BOARD ACTION REPORT - APPEALABLE ITEM

Project Name: McDonalds

Request: Class II Site Plan Modification

ITEM: McDonald's Restaurant (2016-198) – Approval of a Class II Site Plan

L-1

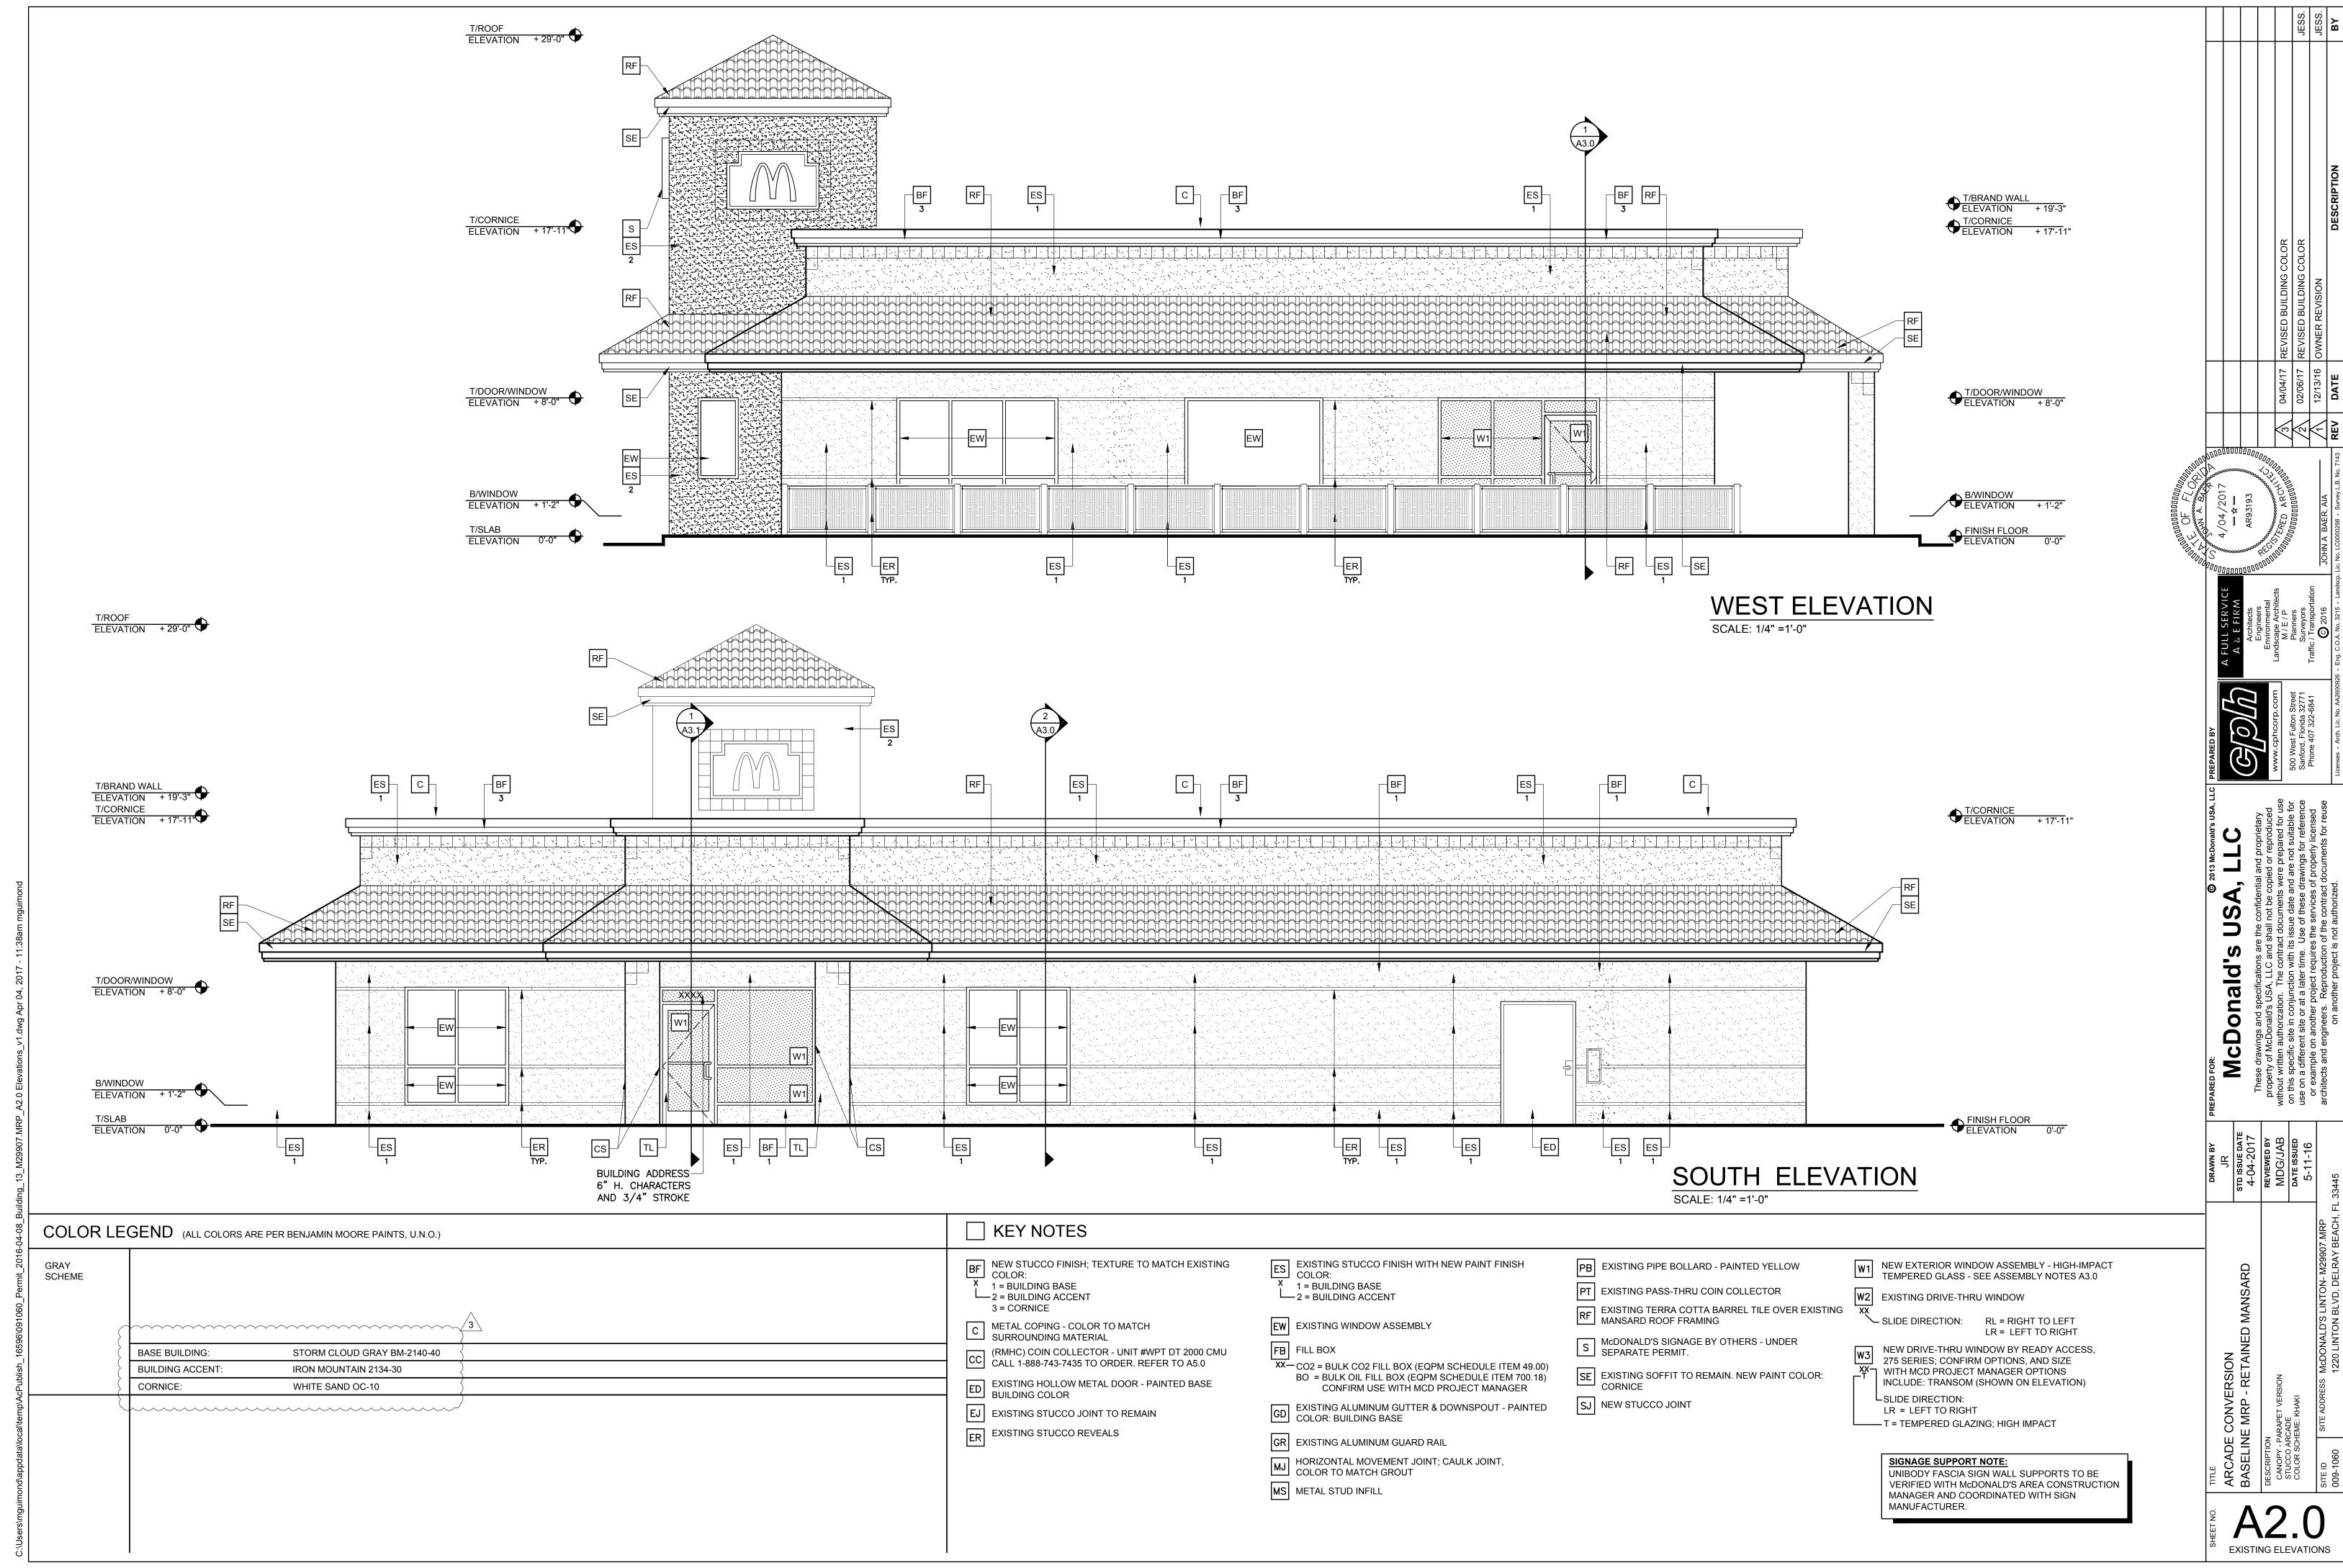
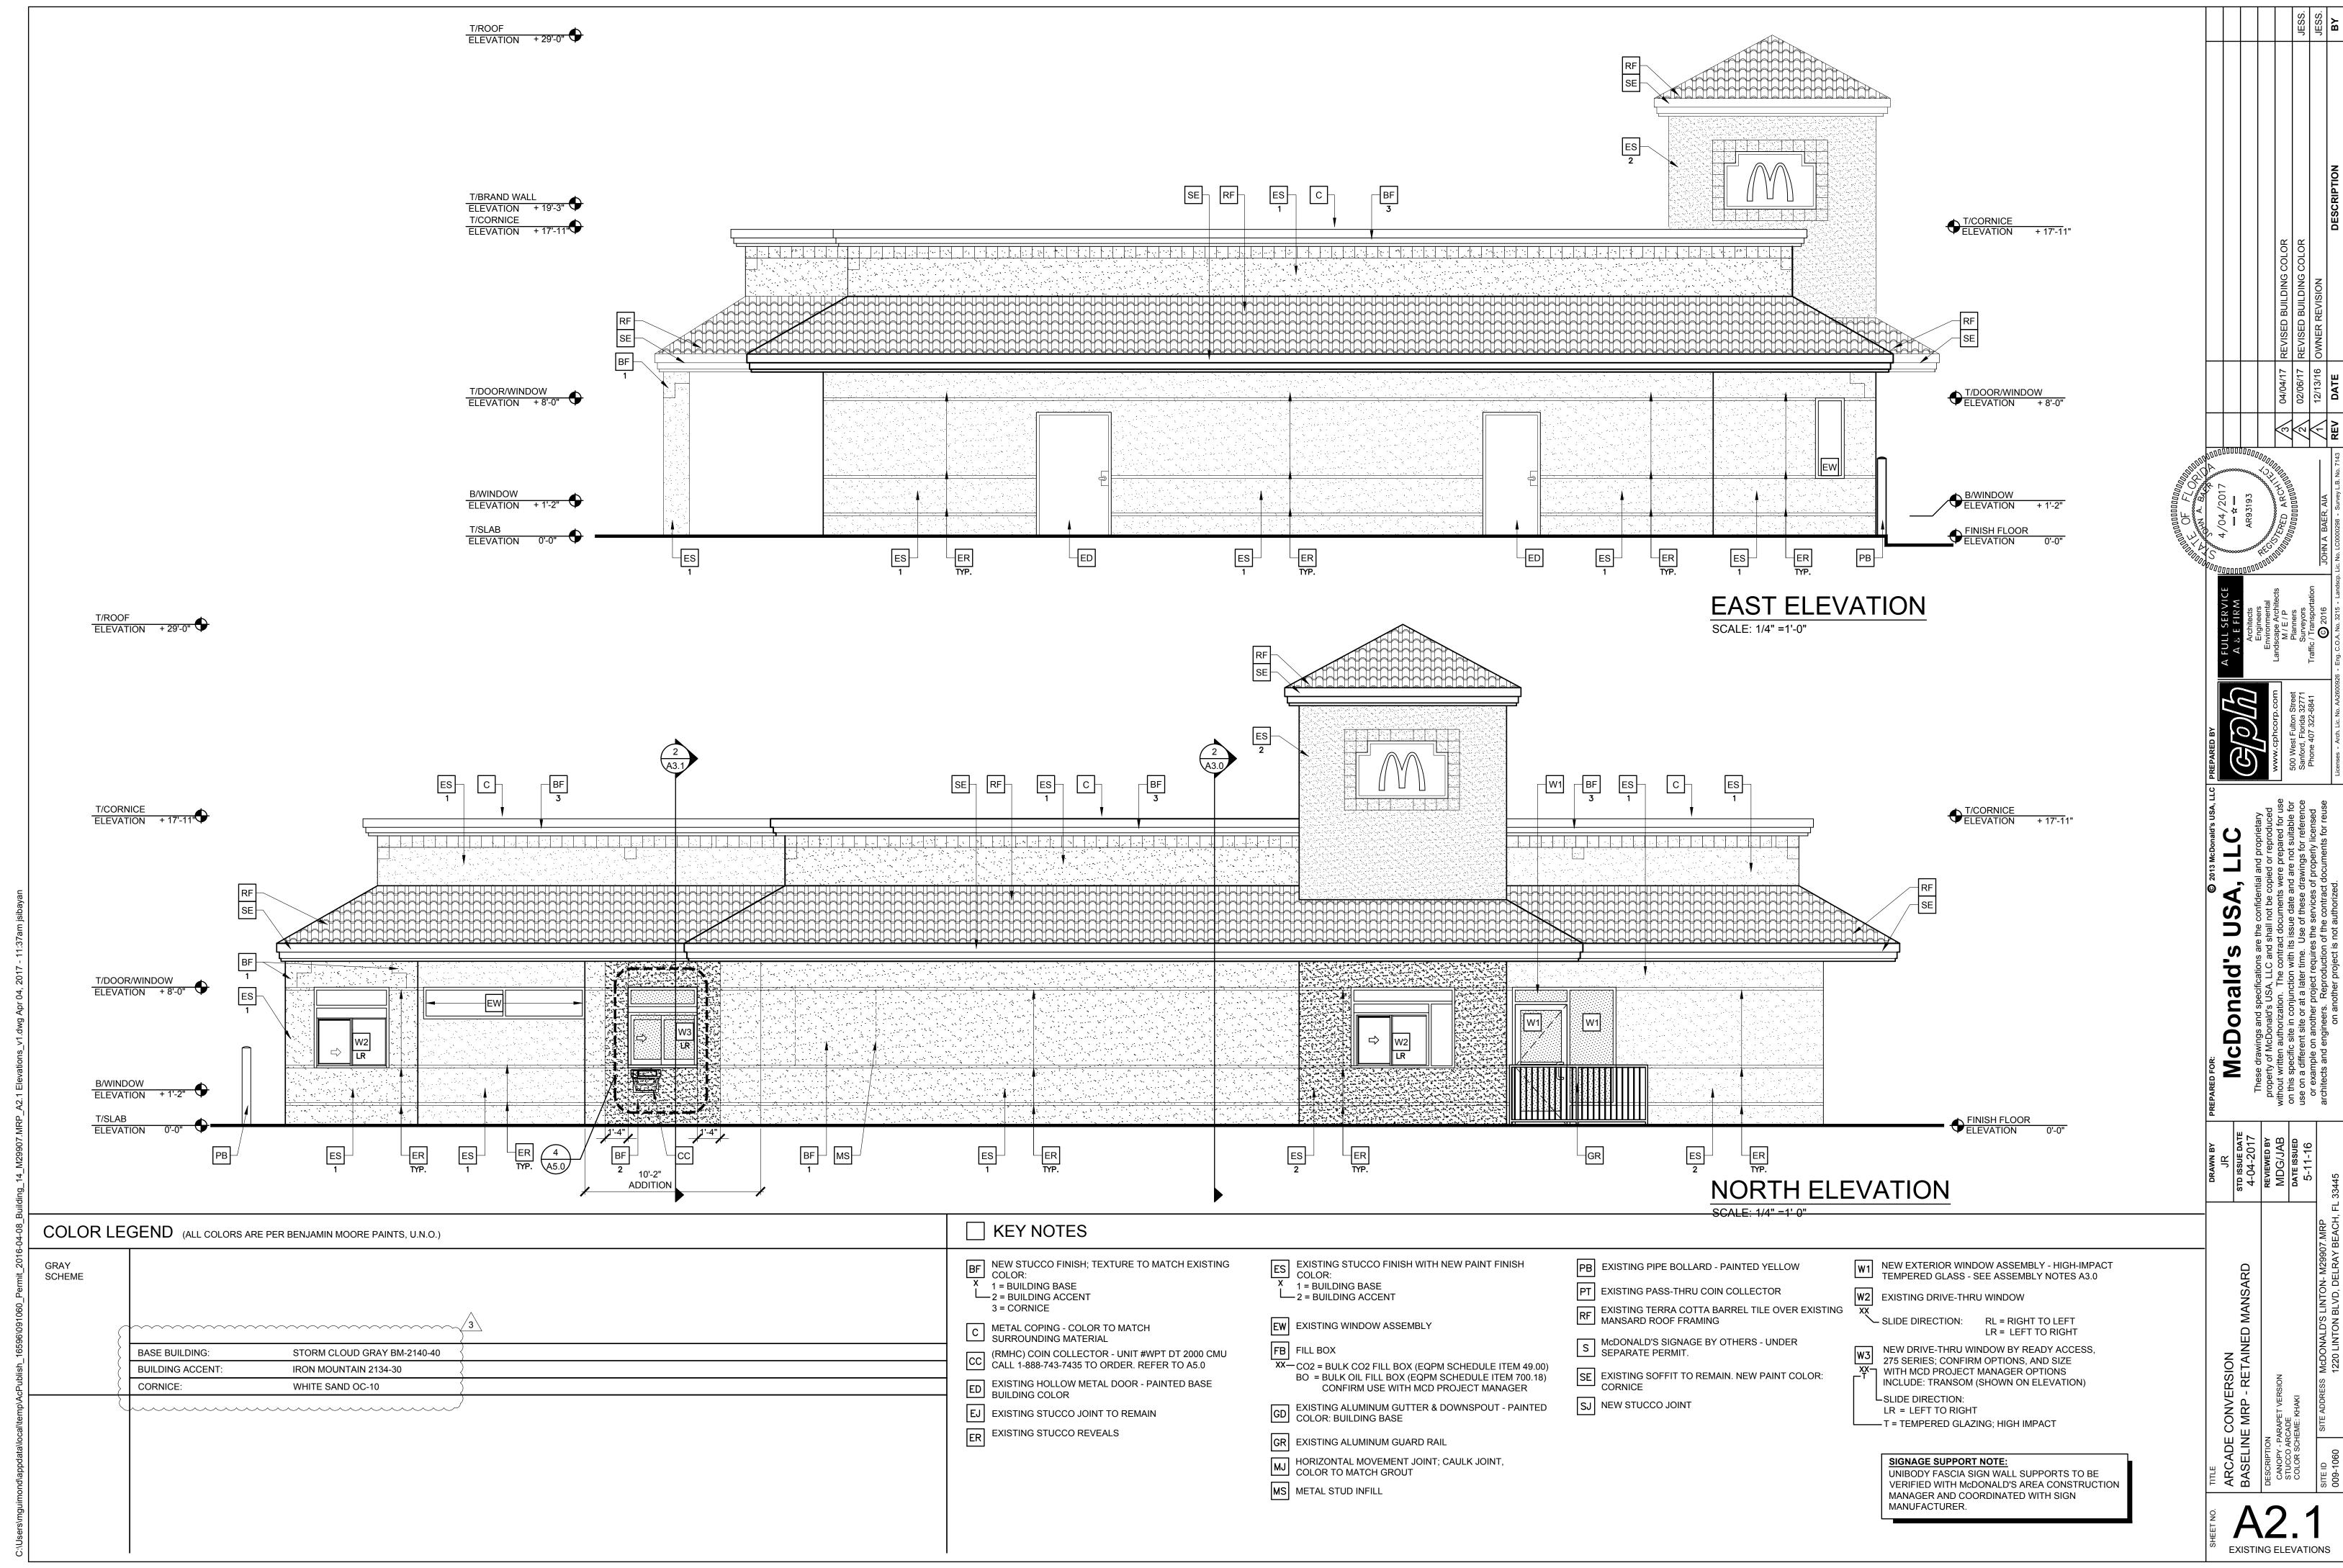
A landscape plan has been submitted, evaluated and recommended for approval by the City Senior Landscape Planner. The applicant is proposing to remove one tree on site that is in front of the proposed delivery ramp. The site is not required to come into compliance with the entire site. Pursuant to LDR section 4.6.16(B)(4) any modification to existing development which results in an increase of 25% in the gross floor area of the structure or structures, situated on the site, the entire site shall be upgraded to present landscape standards. The remainder of the landscaping is minor ground covering that will be concentrated around the building which includes (26) Variegated Blueberry Flax, (38) Dwarf Schefflera and (25) Burford Holly and St. Augustine Sod. While not required, staff recommends that the applicant replace the removed tree in another landscape island.

Approved (4-0, Roger Cope and Laura Sullivan absent) a Class II site plan modification for **McDonalds Restaurant located at 1220 Linton Blvd.**, including landscape plans with the condition that the tree being removed to accommodate the ramp be replaced and architectural elevation changes.

Approve the landscape plan for **McDonald's (2016-198)** located at **1220 Linton Blvd**., by adopting the findings of fact and law contained in the staff report, and finding that the request meets criteria set forth in LDR Section 4.6.16 with the recommendation that the one tree that is removed to accommodate the ramp be replaced somewhere else on site.
